ADDENDUM NO. 1

CITY OF LAS VEGAS DOWNTOWN CORRIDOR IMPROVEMENTS CITY OF LAS VEGAS DEPT. OF PUBLIC WORKS LAS VEGAS, NEVADA		CONFIRMED: 1-16-95 DATE 12/06/94	PLAN AND PROFILE STA. 94+00 TO STA. 106+00		DWG. NO. 107-V-2288 FILE NO. 9903.02 SHEET 23 of 51 SD-6
--	--	--	---	--	---

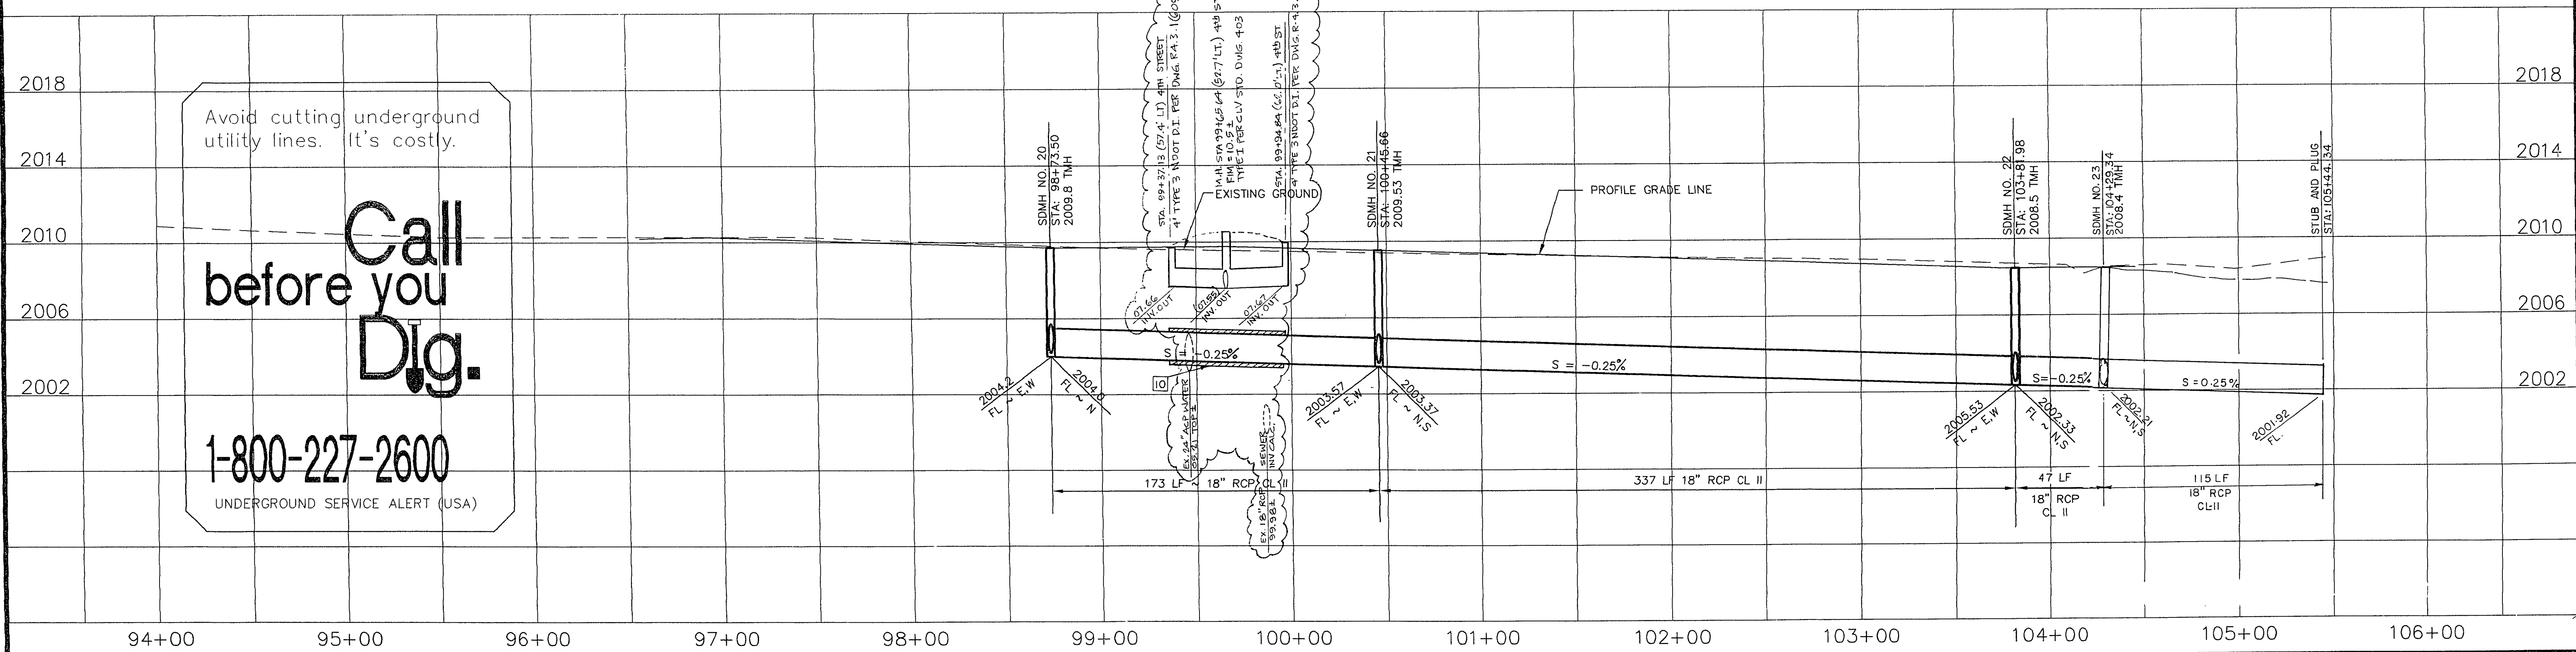
REVISIONS		NO.	DATE	BY
1 REVISION 1, ISSUED AS ADDENDUM NO. 1, ENTIRE SHEET, ADD STORM DRAIN ON PLAN AND PROFILE.		12/10/94	DBB	
2 REVISION 3, ISSUED AS CCO ENTIRE SHEET, ADD UTILITIES IN PLAN AND PROFILE, CONC. ENCASUREMENT, MODIFY STUB OUT ON STEWART, MODIFY CB'S AT STA 103+81.98 TO NDOT TYPE 3.		01/31/95	DBB	
AS-BUILT/AS FOUND IN FIELD		4-96
